19L ABWR Shutdown Risk Evaluation

The information in this appendix of the reference ABWR DCD, including all subsections, tables, and figures, is incorporated by reference with the following departures.

STD DEP T1 2.4-1 (Figure 19L-3)

Figure 19L-3 Potential Path for Draining RPV Through Residual Heat Removal System (Pump On)

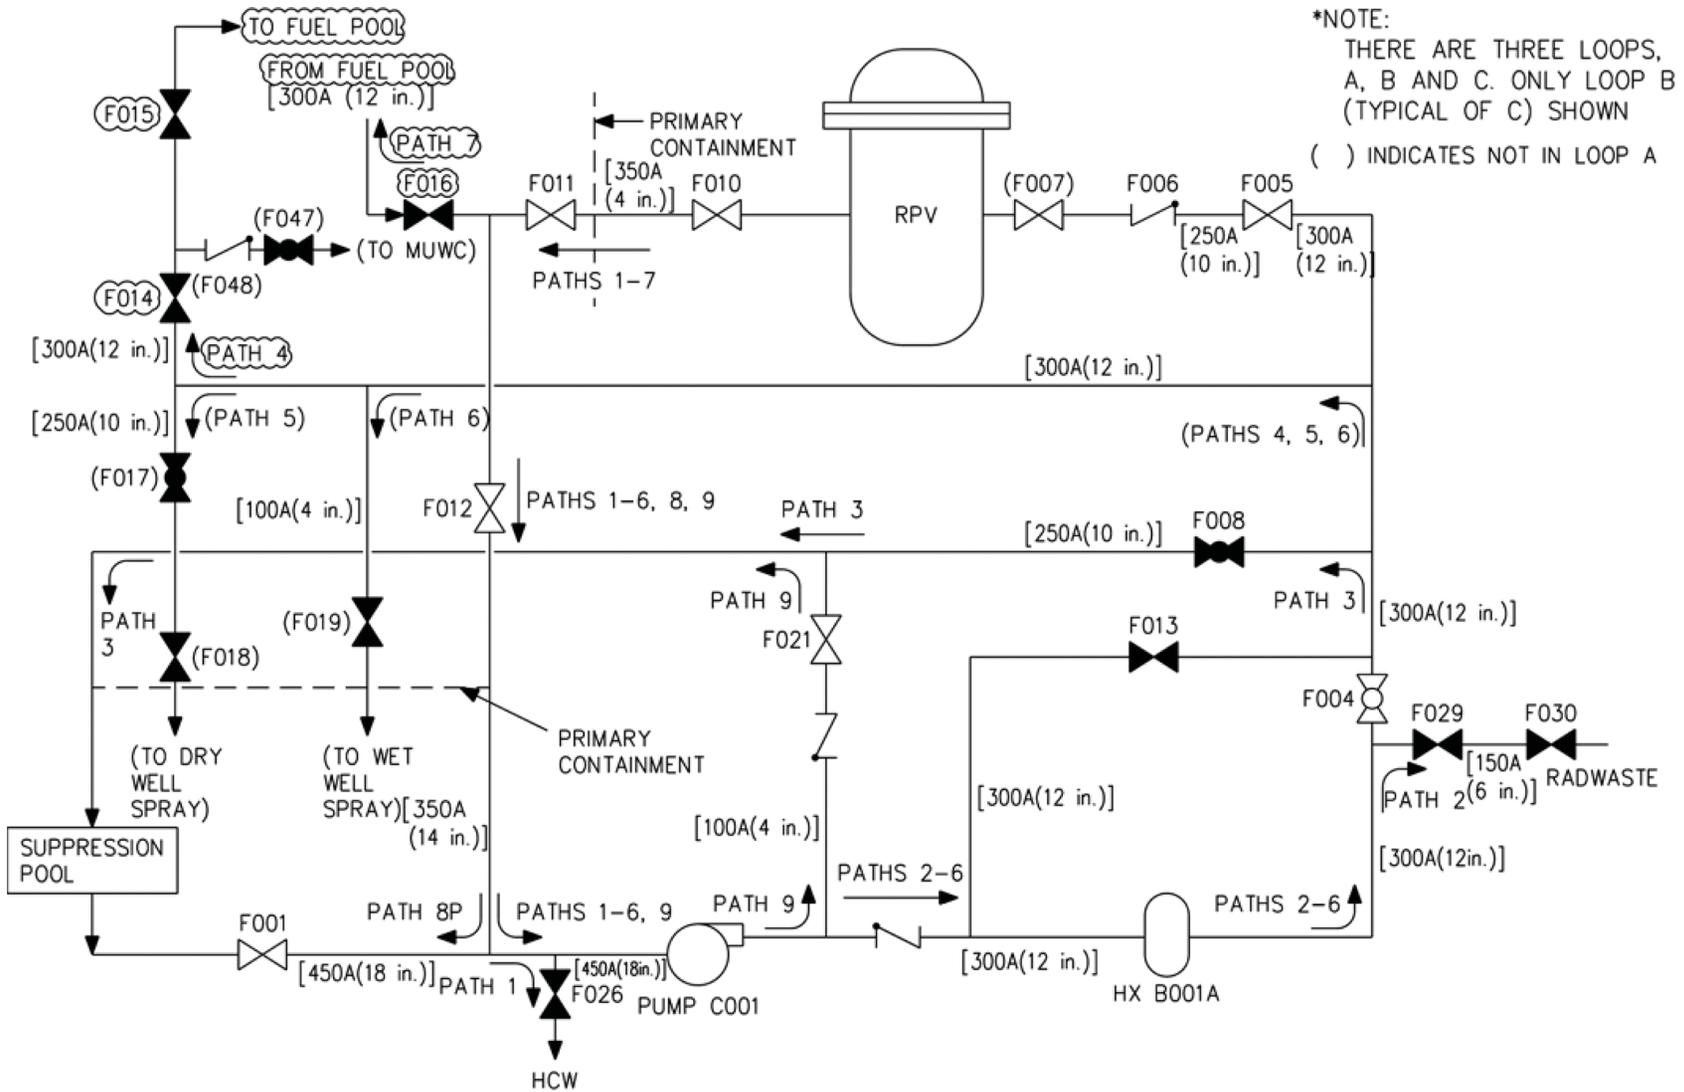
STD DEP T1 2.4-1 (Figure 19L-3)

The residual heat removal (RHR) design will have three RHR loops connected to the fuel pool cooling and cleanup system (FPCCS) instead of two for the reference ABWR DCD with normally closed inter-ties to permit additional supplemental cooling during refueling outages to reduce outage time.

Increasing the number of RHR loops connected to FPCCS from two to three results in a decrease in CDF, because it is an improvement of the outage management control for the fuel pool cooling system.
